Title - Sujet Health Care Expansion	
Solicitation No. - N° de l'invitation EZ899-181607/A	Amendment No. - N° modif. 004
Client Reference No. - N° de référence du client	Date 2017-12-06
GETS Reference No. - N° de référence de SEAG PW-\$PWY-025-8228	
File No. - N° de dossier PWY-7-40258 (025)	CCC No./N° CCC - FMS No./N° VME
Solicitation Closes - L'invitation prend fin at - à 02:00 PM on - le 2017-12-20	Time Zone Fuseau horaire Pacific Standard Time PST
F.O.B. - F.A.B. Plant-Usine: <input type="checkbox"/> Destination: <input checked="" type="checkbox"/> Other-Autre: <input type="checkbox"/>	
Address Enquiries to: - Adresser toutes questions à: Fung, Donna(PWY)	Buyer Id - Id de l'acheteur pwy025
Telephone No. - N° de téléphone (604) 671-9689 ()	FAX No. - N° de FAX (604) 775-6633
Destination - of Goods, Services, and Construction: Destination - des biens, services et construction: CSC - Mountain Institution - Agassiz, BC

This Amendment No. 004 is raised to incorporate Addendum #01.

ADDENDUM #1

PROJECT: Mountain Institution Health
Care Expansion

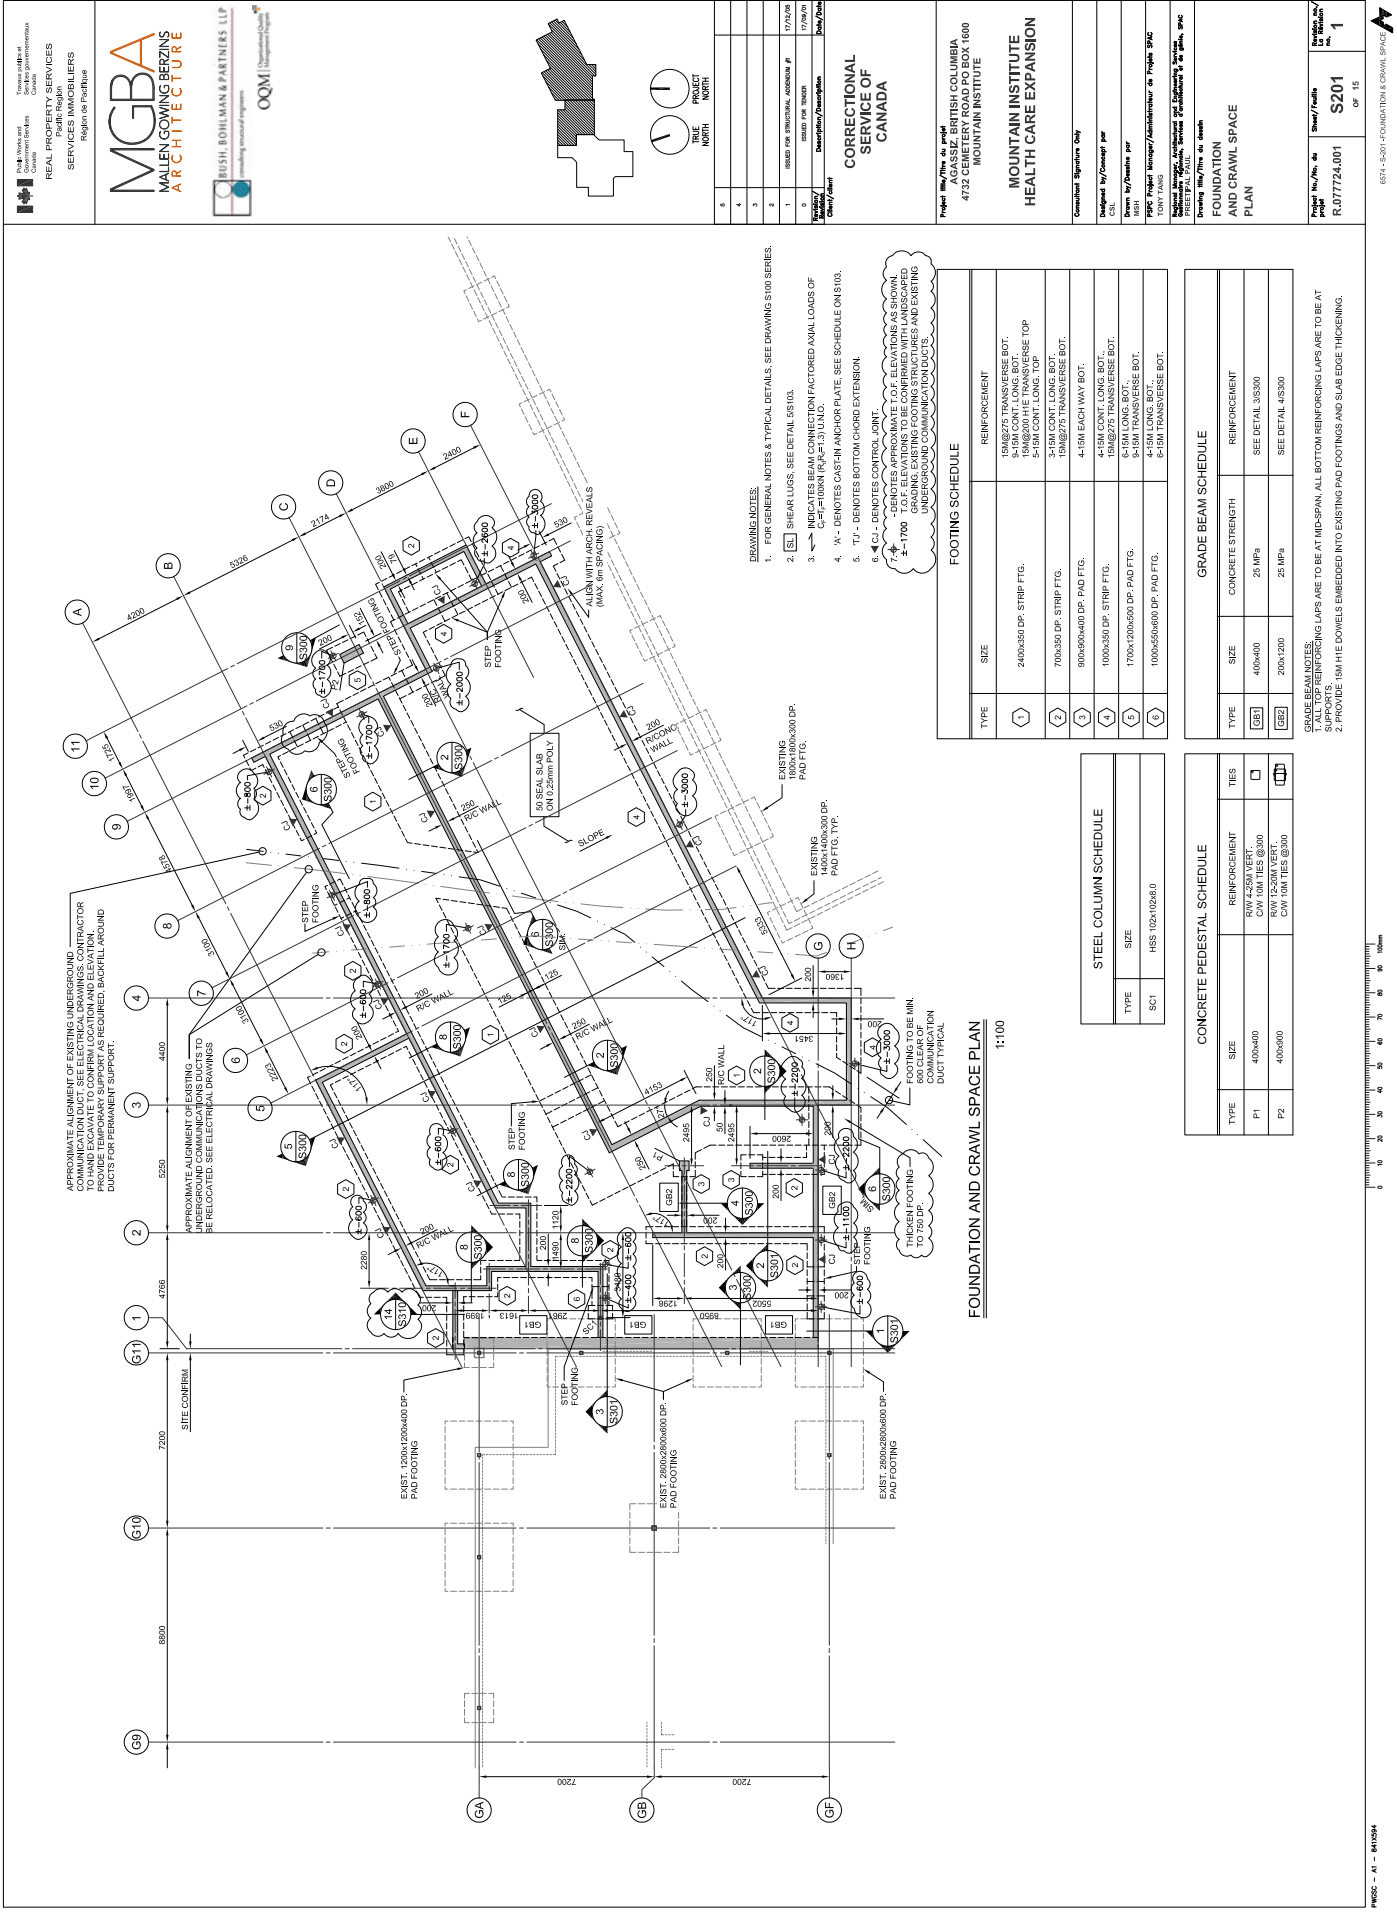
1. Refer to drawing S201:
 - a. Added top of footing elevations.
 - b. Added additional steps where required.
 - c. Added detail 14/S310.
2. Refer to SSK-01:
 - a. Revised detail call-out.
3. Refer to SSK-02, SSK-03, SSK-04, SSK-06:
 - a. Revised footing depth.
4. Refer to SSK-05:
 - a. Revised block-out depth for HSS column.
5. Refer to SSK-06:
 - a. New strip footing detail.

SSK-02

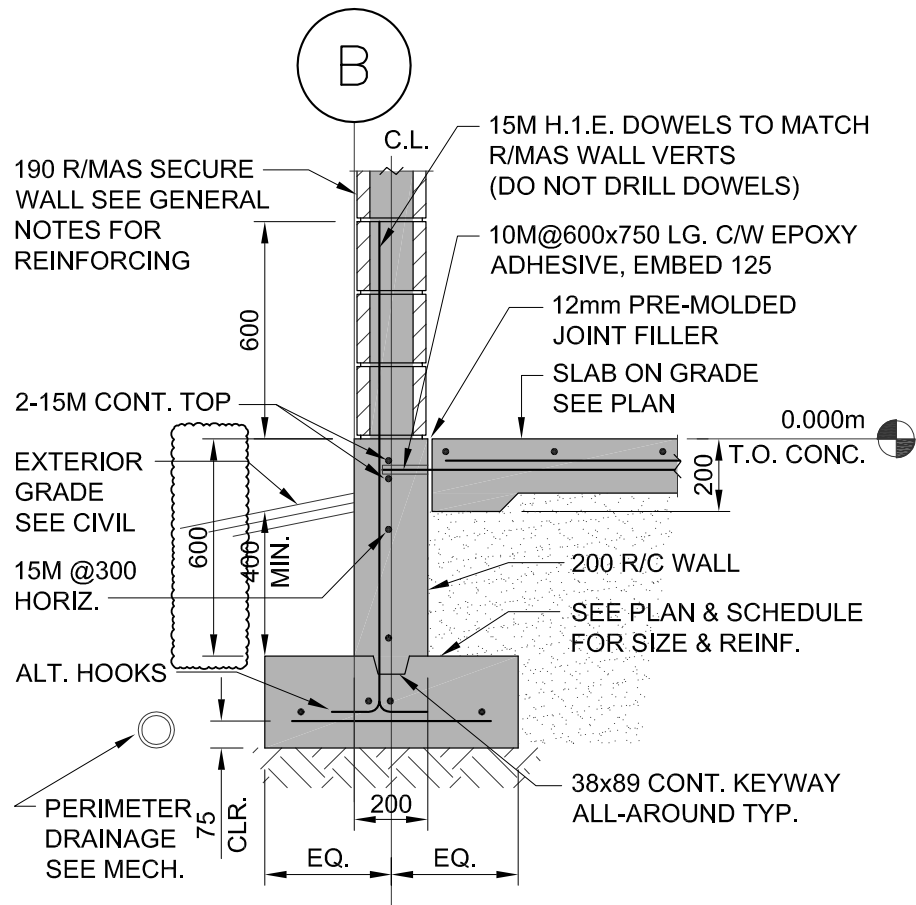
- a) **[REVISE]** drawing per Structural Addendum #1 Sketch SSK-01
- .5 Reference: **DRAWINGS** Drawing S300 SECTIONS AND DETAILS SHEET 1
- a) **[REVISE]** detail 8/S202 per Structural Addendum #1 Sketch SSK-02

FOOTING DEPTH CLARIFIED

SSK-03

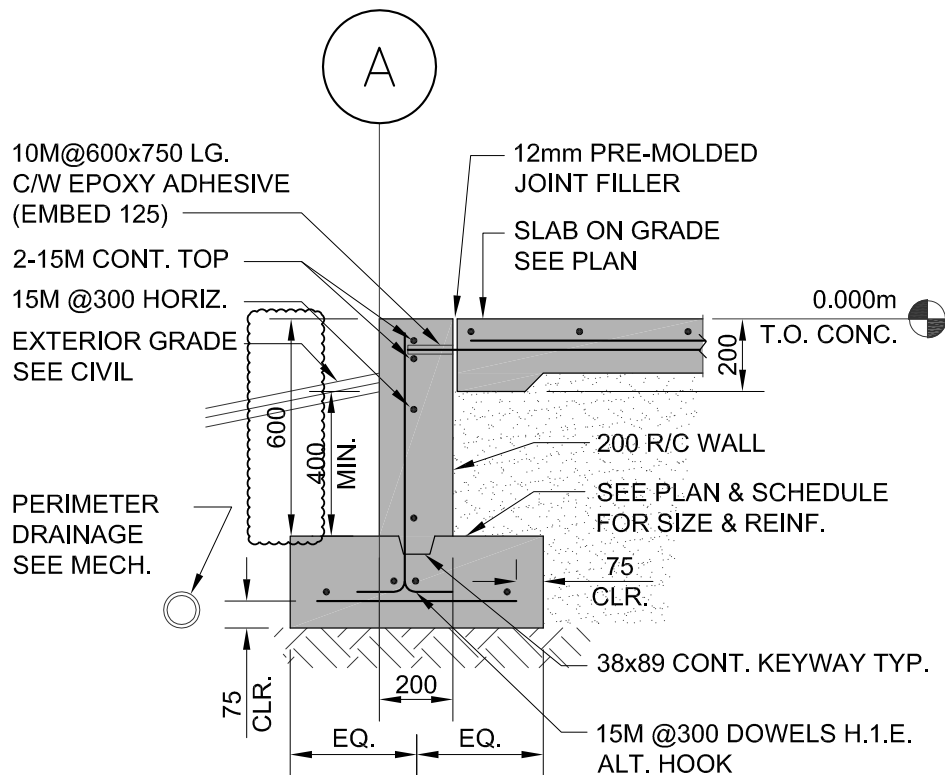
- .6 Reference: **DRAWINGS** Drawing S310 SECTIONS AND DETAILS SHEET 3
- a) **[REVISE]** detail 5/S202 per Structural Addendum #1 Sketch SSK-03
 - b) **[REVISE]** detail 6/S202 per Structural Addendum #1 Sketch SSK-04

FOOTING DEPTH CLARIFIED

SSK-04

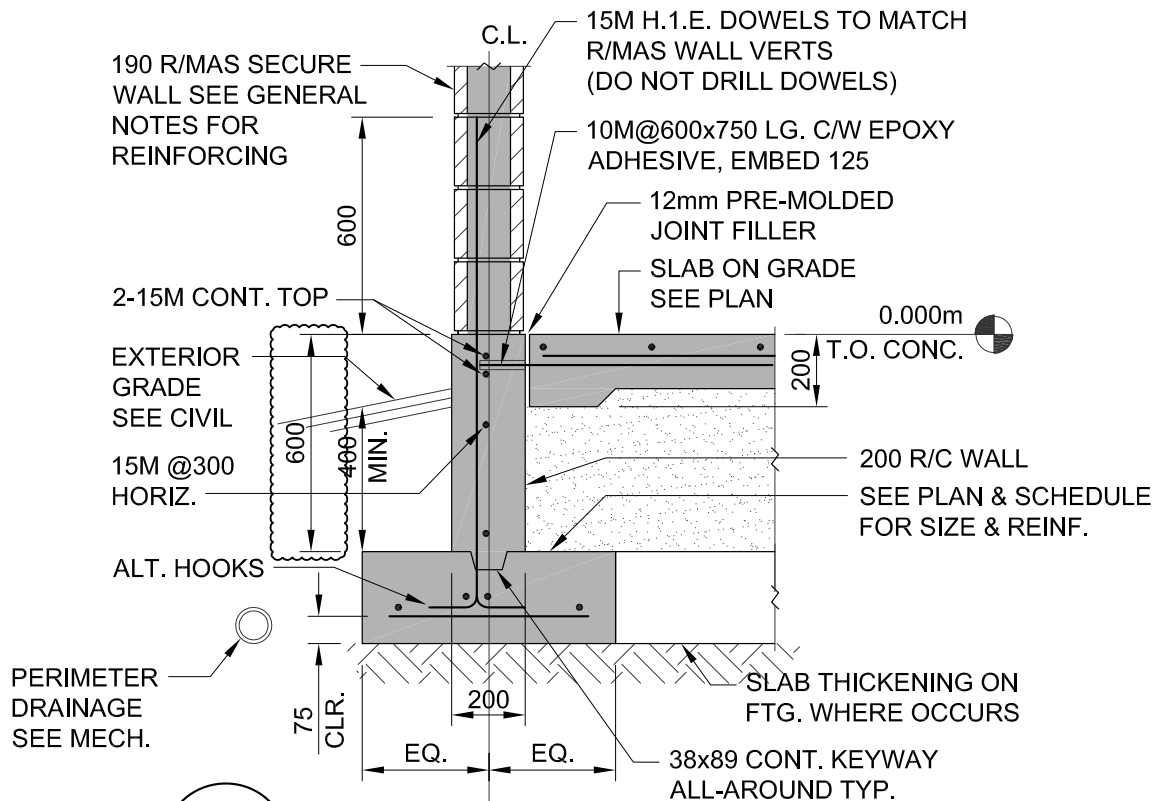
FOOTING DEPTH CLARIFIED
